# VERIFICATION AND CERTIFICATION REPORT

## MOKPO LANDFILL GAS RECOVERY PROJECT FOR ELECTRICITY GENERATION

REPORT No. 2013-10

VERSION NO. 01.1

[Figure 1] Layout of monitoring equipment

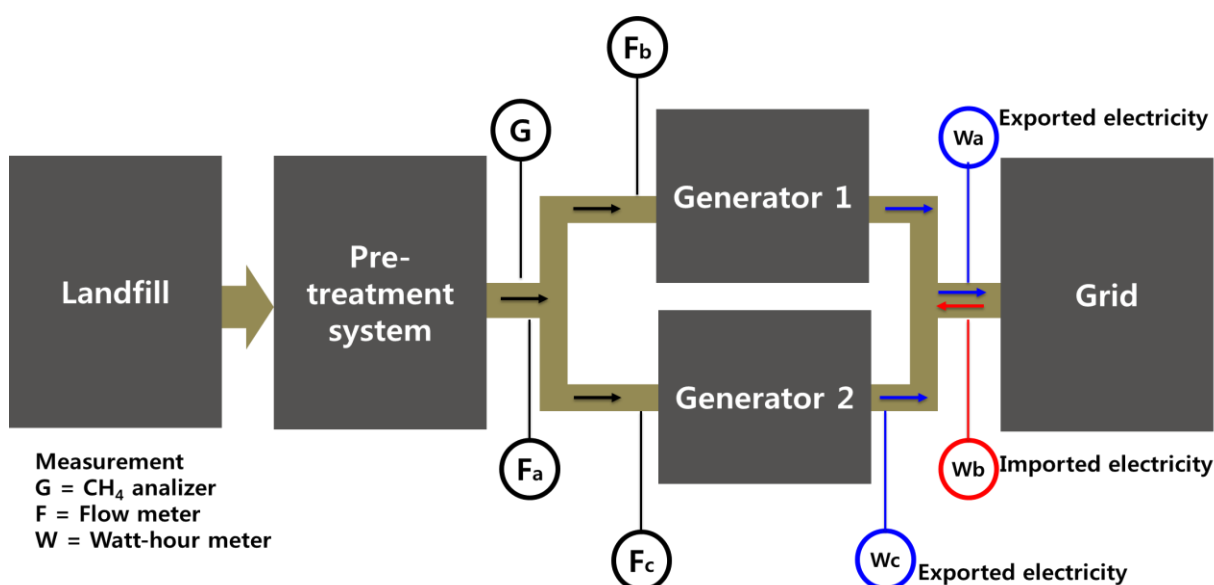
Until the 3<sup>rd</sup> monitoring period, 3 flow meters ( $F_a$ ,  $F_b$ ,  $F_c$ ), 1 gas analyzer ( $G$ ) and 2 watt-hour meters ( $W_a$  /  $W_b$ ) were installed for the monitoring and in this 4th monitoring period, 1 watt-hour meter ( $W_c$ ) is added to measure exported electricity from generator 2.

Before Gas analyzer and LFG flow meter, there is a pre-treatment system. The pre-treatment has moisture removal facility by means of cooling the LFG. From the specification of facility, the output temperature from the facility is designed under 10 °C. From the ‘Tool to determine the mass flow of a greenhouse gas in a gaseous stream (version 02)’, less 60 °C temperature of gaseous stream is the criteria of dry gas condition. The verification team checked the design data sheet of moisture removal facility installed on the project site and operation status. It is checked that the pre-treatment system is well operated during monitoring period and there was no operation failure through checking daily work log. Thus, it is confirmed that all data of flow meters and gas analyzer were measured under dry basis.
